**COUNTY OF HUMBOLDT EXTRACTION REVIEW TEAM (CHERT)
2001 POST-EXTRACTION REPORT**

DISCUSSION DRAFT

April 2, 2003

Schematic of Various 2002 Grades at Johnson-Spini Left Bank Bar

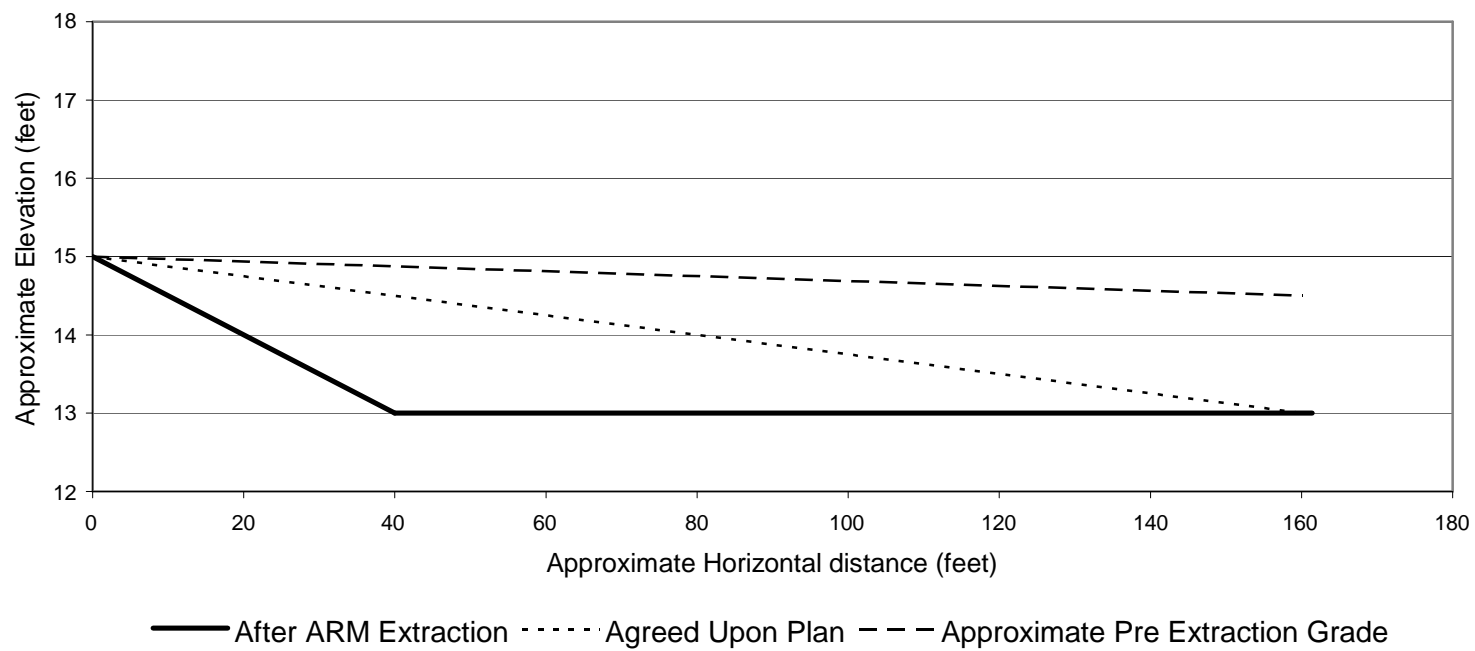
<p>Was the extraction volume at this site within the approved plan limits? <i>Yes.</i></p>		
<p>Was the entire post extraction footprint essentially within the approved plan limits? <i>Yes.</i></p>		
<p>Was the entire post extraction bar surface elevation essentially within the approved plan limits? <i>No. A condition of the plan approval was that the excavation floor would begin to rise at cross section 13 and would daylight at cross section 4. (The distance between cross section 13 and cross section 4 is 160 feet.) Arcata Readimix clearly agreed to do this and it was made a condition of the plan approval. Apparently, neither the surveyor nor the equipment operators were informed of this condition. Instead, the operators maintained the elevation of the excavation floor while moving upstream from cross section 13 for a distance of about 120 feet to 140 feet (distance varied) and then abruptly rose 2 to 3 feet to daylight (within 20 to 40 feet) at cross section 4. A schematic sketch follows.</i></p>

<p>Was the amount of vegetation disturbance essentially within the approved plan limits? <i>Yes.</i></p>		
<p>Were the vertical and horizontal buffers essentially within the approved plan limits? <i>At the time of the post extraction inspection, the vertical buffer between the excavation floor and low flow water surface was only a few inches at several locations along the edge of the excavation.</i></p>		
<p>Was the entire post extraction surface essentially free draining? <i>No. After the bar was inundated, water ponded at the upstream end of the excavation.</i></p>		
<p>Does it appear that all stream crossings were reasonably installed and removed? <i>There was no bridge required for this excavation. However, a bridge was located on this bar to gain access to the right bank bar. The bridge installation and removal appears reasonable. The bridge crossing was actually about 200 feet downstream from where the plan indicated that it was supposed to be located.</i></p>

Are all other extraction compliance issues within expected limits? No. On September 7, 2001 CHERT was notified by the Humboldt County Planning Department that Arcata Readimix does not possess a mining right for the left bank bar and that Arcata Readimix must cease mining on that bar.

If impacts were not within expected limits, how could have these impacts been avoided or reduced? Had the operator submitted cross section 4a with their plan CHERT would likely have noticed that the surveyor was not aware of the agreement that had been reached during consultations with CHERT, the California Department of Fish and Game and Arcata Readimix. Action could then have been taken to communicate the approved plan throughout the Arcata Readimix organization. Had CHERT required additional planning survey information, for example a sketch of the pre extraction and proposed bar surface profile, CHERT would likely have noticed that the surveyor was not aware of the agreement. Action could then have been taken to communicate the approved plan throughout the Arcata Readimix organization. CHERT provided a written description of the plan concept. If the operator had read the agreement and communicated its content to their surveyor their surveyor would have understood the plan concept or at least might have questioned the apparent differences between what the operator wanted to do and the CHERT recommendation. When in doubt, the Corps or CDFG could require the operator to carefully explain the excavation plan to their consultants and surveyors in the presence of knowledgeable regulatory witnesses. Furthermore, the plan and boundary markings could be explained to equipment operators in the presence of knowledgeable regulatory witnesses prior to beginning extraction.
